Product Change Notification

Product Series Involved: 34 Series Relay, 38 Series Module, 39 Series Module

Type of Change: Major

Key Change: Aesthetical

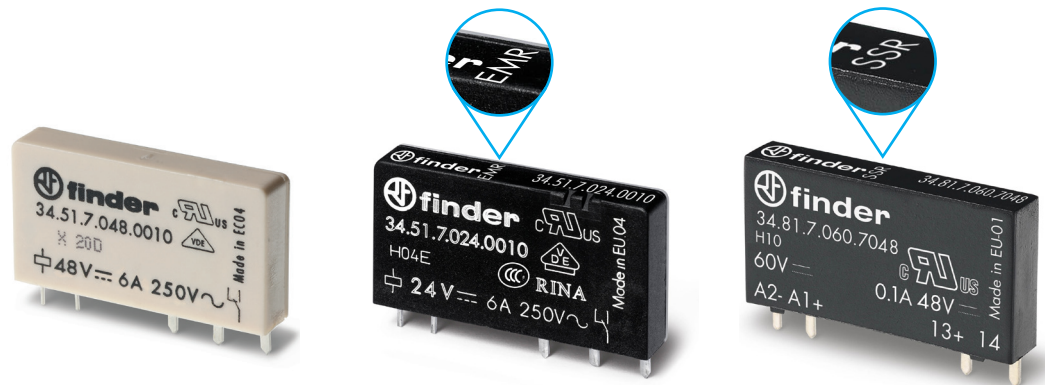
Old 34 Series – White housing for EMR (electro-mechanical relays) or black housing for SSR (solid state relays) with specifications and number printed on the side of the relay. No identification printed on the top.

New 34 Series – Black housing for both EMR (electro-mechanical relay) and SSR (solid state relay). Printing is located on the side of the relay as well as additional identification now on the top. The improved printing on the top will state Finder; EMR or SSR; and full part number. The EMR relay will also include a translucent back cover.
